# Service Bulletin

Model: DTC-57ES/670/750

No. 359

Subject: Intermittent Audio, Mechanism Wrinkles Tape

Figure 1

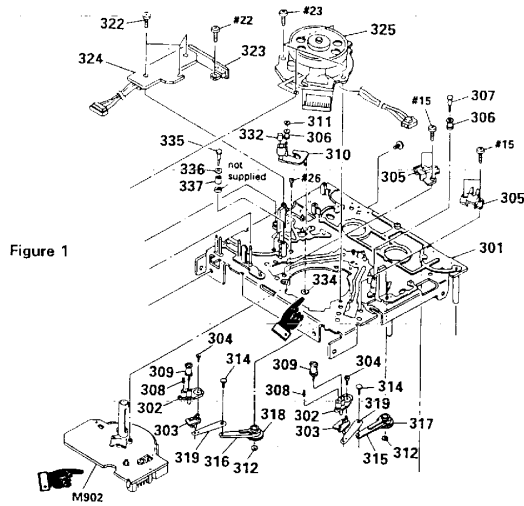
1. Remove the Capstan Motor M902 (see Figure 1).
2. Remove the Pinch Roller Assembly by removing the retainer washer (ref. 334) and lifting the Pinch Lever Assembly from the top side of the mechanism.
3. Install new Pinch Roller Assembly and replace retaining washer.

Figure 3

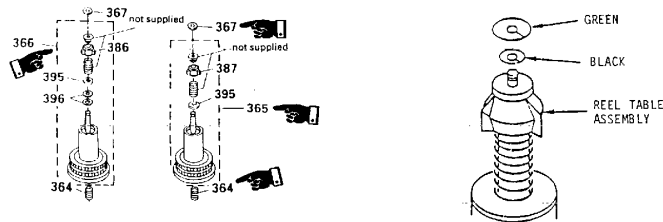
1. Remove the retaining washers (ref. 367) and the reel tables (ref. 365 and 366) and replace the compression springs (ref. 364) with the ones supplied in the repair kit.

*Note: If the reel table assembly is equipped with a black spring, it is necessary to replace the entire reel table assembly with the new reel table assembly (A-2003-710-B).*

2. Re-install the reel tables and secure them using the locating washers (black) and the retaining washers (green) supplied in the repair kit. The black locating washers should be installed first and the green retaining washers on top as shown in the detail of Figure 3.

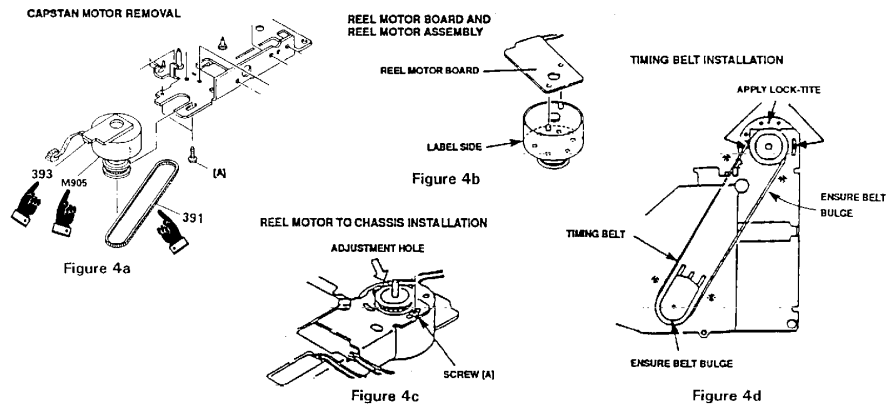
1. Remove screw (A) from reel motor and remove reel motor assembly (M905), timing belt (ref. 391) and the reel motor board (ref. 393) (see Figure 4a).
2. Solder reel motor board (ref. 393) to reel motor assembly M905 (see Figure 4b).
3. Loosely fasten reel motor assembly to the chassis with screw (A) (see Figure 4c).
4. Install timing belt (ref. 391) between reel motor assembly and reel drive gear assembly (ref. 358). The belt should bulge slightly in the areas indicated (see Figure 4d).
5. Securely tighten screw (A) and carefully apply lock-tite as shown in Figure 4d.

Figure 5

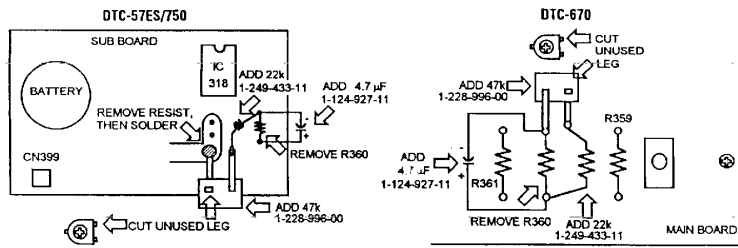
1. Remove R360 (see Figure 5).
2. Add a 22K ohm resistor and a 47K ohm potentiometer and a 4.7uF capacitor as shown in Figure 5.

Figure 6

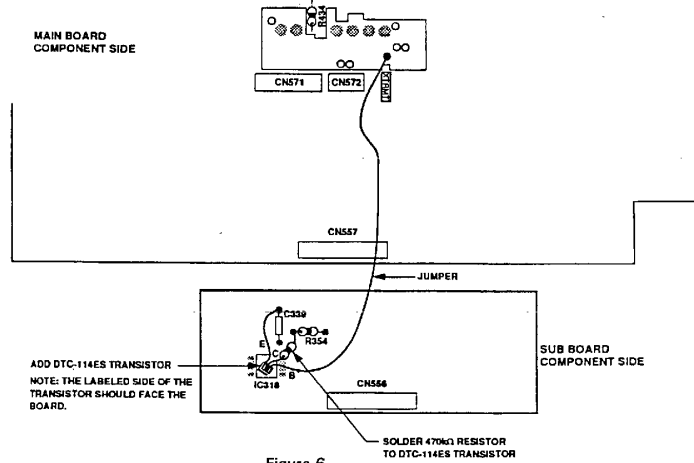
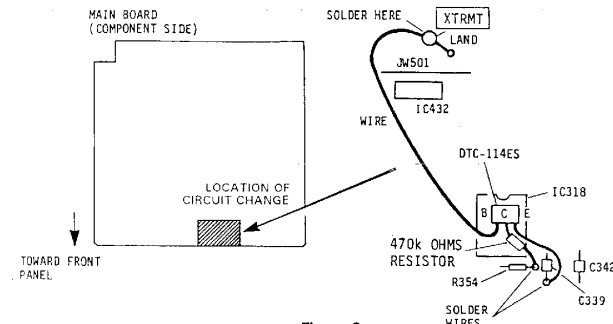
1. Solder a 470K ohm resistor supplied in the kit to the collector of the DTC-114ES transistor supplied in the kit (see Figure 6).
2. Add a DTC-114ES transistor to the Sub and Main boards as shown, adding a jumper wire between the base of the transistor and test point XTRMT on the Main board.

Figure 7

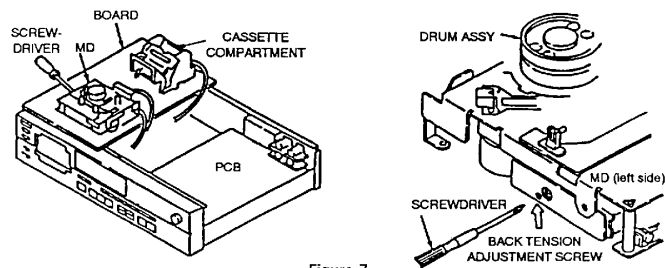
1. Remove the mechanical deck and the cassette compartment from the unit and separate the two assemblies. Place the two assemblies on a board without disconnecting any electrical connections (see Figure 7).
2. Put the unit in the test mode, insert a TW-7131 torque test tape (P/N 8-909-708-71) and press the forward button on the unit.
3. Adjust the back tension by slightly turning the adjustment screw located on the left side of the mechanism.
4. Changing modes once or twice (ie. PLAY - PAUSE - PLAY) during the procedure ensures an accurate adjustment. The back tension should be adjusted to 5.0 g/cm to 6.0 g/cm.
5. Check that this value remains steady for one revolution of the torque meter. **This adjustment should be completed before one minute has elapsed as the torque will begin to vary when the plunger begins to heat up.**

Figure 14

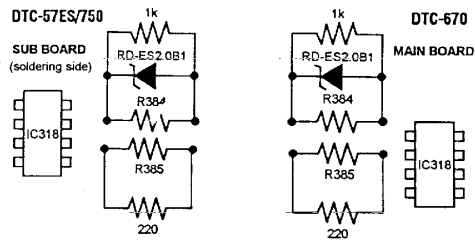
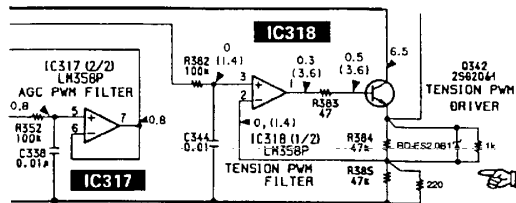
*Note: It is critical that all back tension adjustments are performed prior to the addition of the components shown below. Adjustment of the back tension will not be possible after these components are installed. If back tension adjustment is necessary after the above components are installed, it will be necessary to remove these components.*

1. Mount a 1K ohm resistor and an RD-ES2.0B1 Zener diode (both supplied in kit) parallel to R384 (see Figure 14). Note the orientation of the Zener diode.
2. Mount a 220 ohm resistor in parallel with R385 (see Figure 14).
